CAMP HIAWATHA ADDITION

TO WICHITA, SEDGWICK COUNTY, KANSAS

Re: S/D 95-66 CAMP HIAWATHA ADDITION (Final Plat)

STAFF REPORT

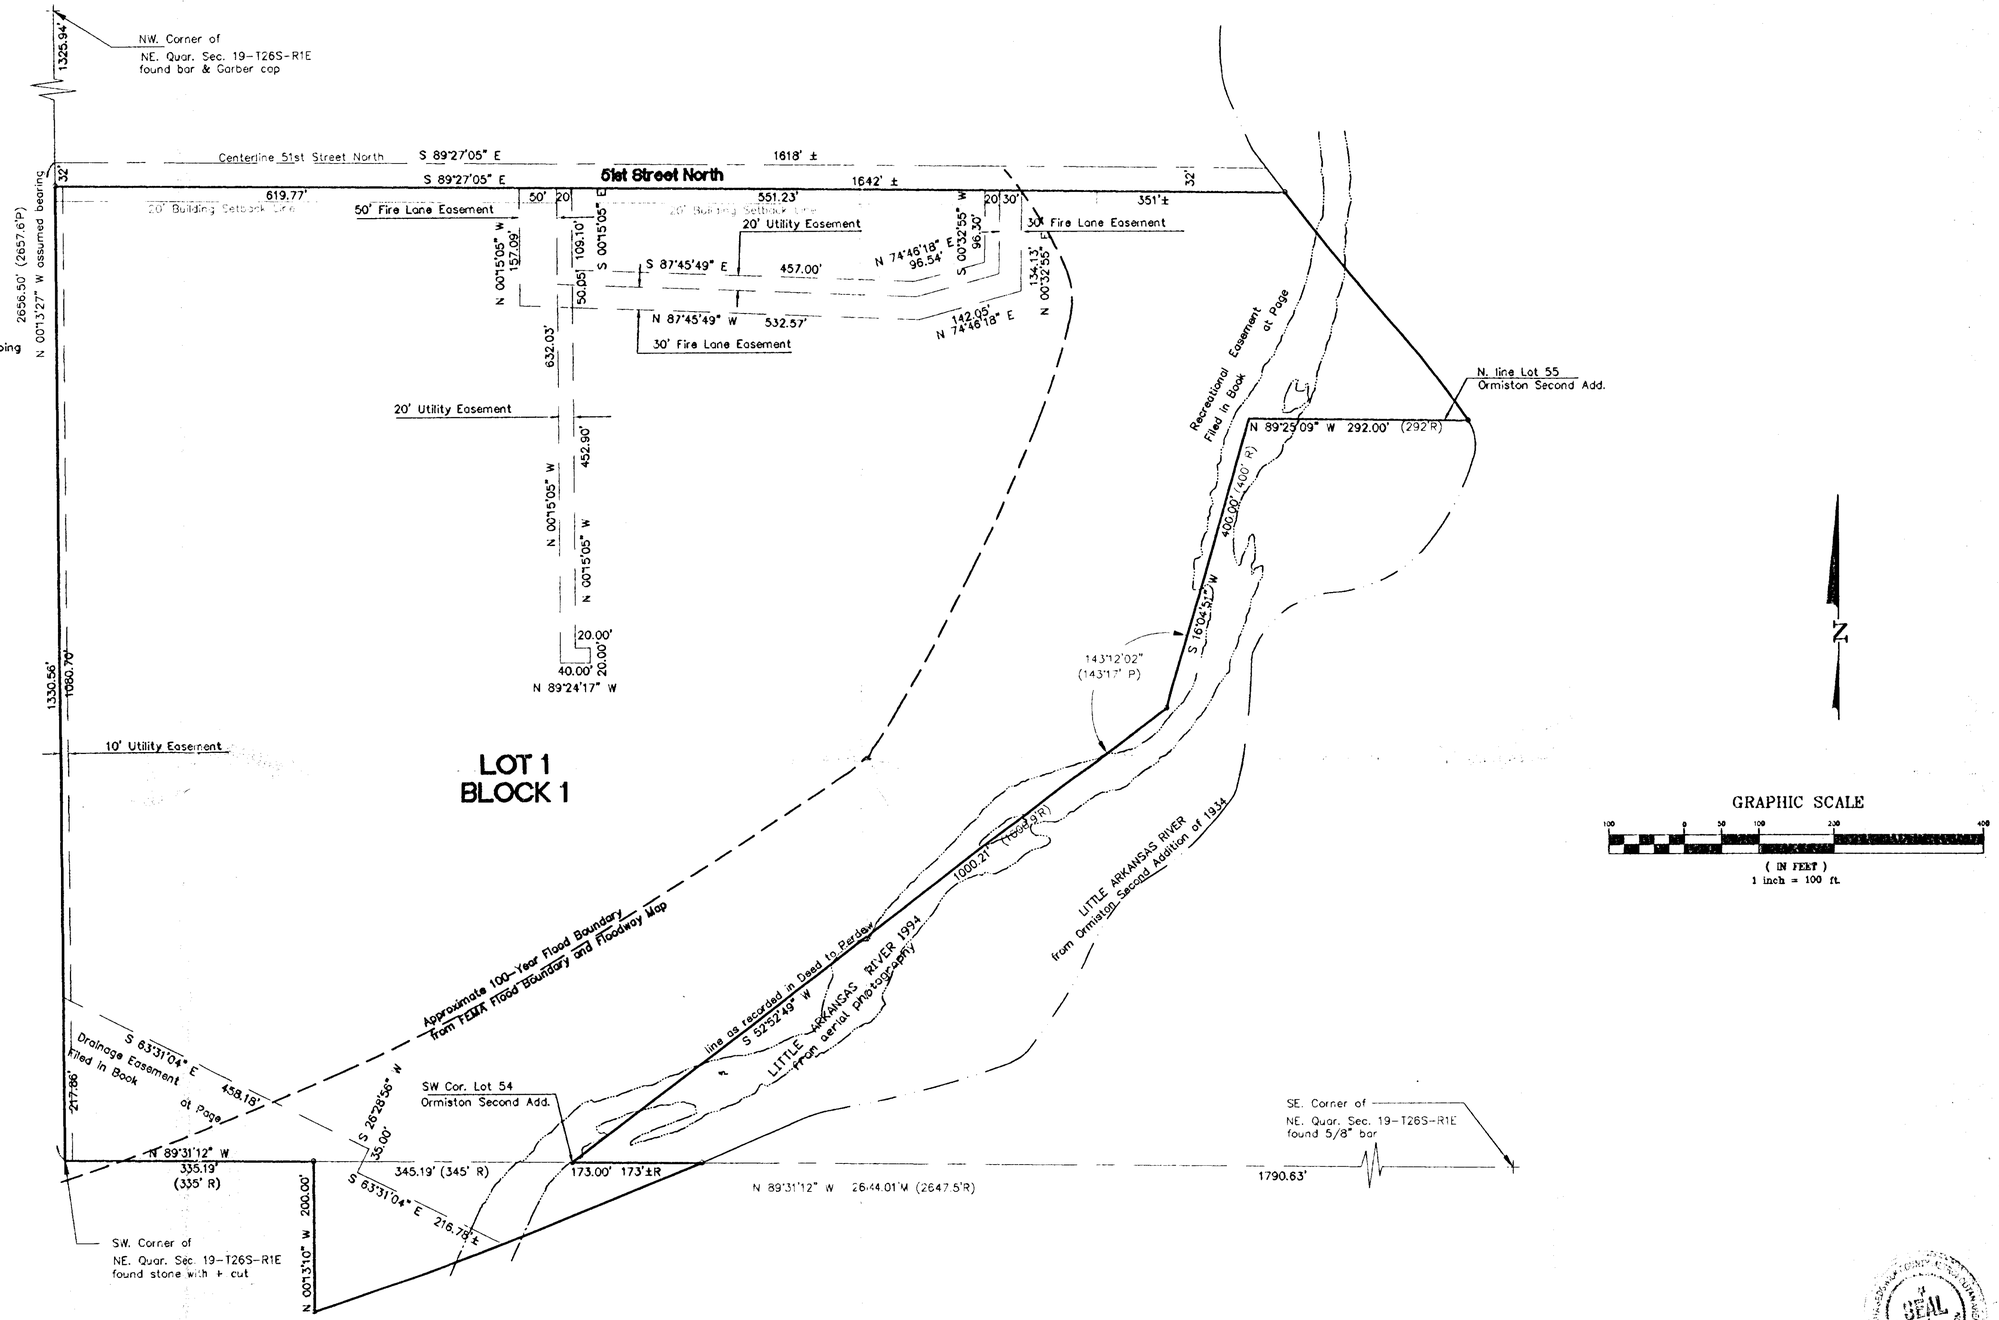
H. Since this plat shows the platting of a floodway, the final plat tracing shall reference in the plattor's text the standard floodway language.

J. On the final plat tracing, the recording information for the drainage easement at the southwest corner of the site shall be provided.

K. The perimeters of plats or at least lots are typically, if not always, shown by solid lines. This final plat, however, is using dashed lines at the northeast and southwest corners of the plat. The legend indicates that such symbols are also indicating the centerline of the river as of 1934 platting. The applicant's agent needs to clarify if the final plat tracing will also show dashed lines for these sections of the plat and the justification for doing so.

L. Since this plat is platting a floodway, minimum building pad elevations would typically also be required. City Engineering needs to indicate if minimum building pad elevations are required. If required, the elevation shall be noted both on the face of the plat and in the plattor's's text.

R. On the final plat tracing, the City Clerk's signature line shall be amended to delete Deputy.

T. The final plat shall indicate the utility easements requested by K.G.& E. -Electric which are indicated on the enclosed "marked" copy of the plat.
